PART 573 Defect and Noncompliance Report

03V-258 ① of ②

Bulletin #: IMCSB-057

Safety Recall of Teardrop Headlight

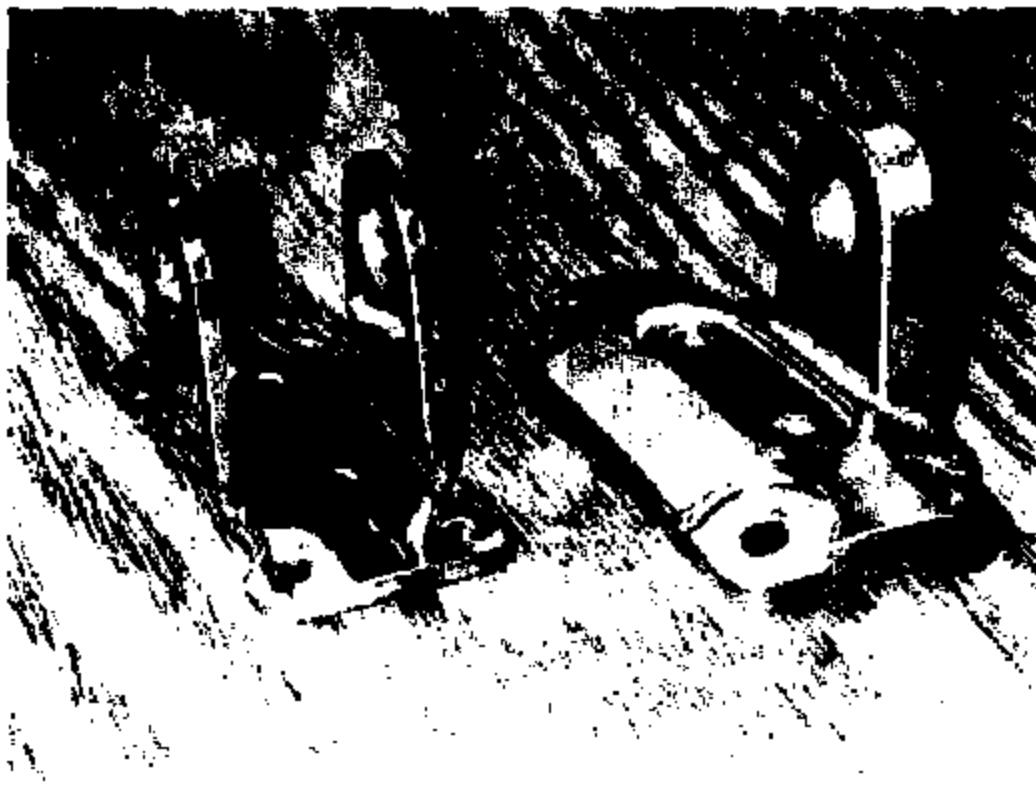
The design of the mounting bracket for the teardrop headlight incorporates a bend at the point that the bracket arms fold, the radius of which is too small causing stress loads in excess of the material capability. The failure of the bracket design to adequately distribute the stress load leads to cracking at the bend point in the mounting bracket. In the most extreme case, the cracks can radiate through the bracket, causing the bracket to break and the light to slump out of position or even fall off. See picture of the old and new brackets in 5.1.

IMC designed a new bracket that is a single metal casting as opposed to stamped and formed steel. The use of a casting eliminates the bend radius issues that had caused cracking in the original part, and the cast bracket is much more robust in terms of the amount of material used.
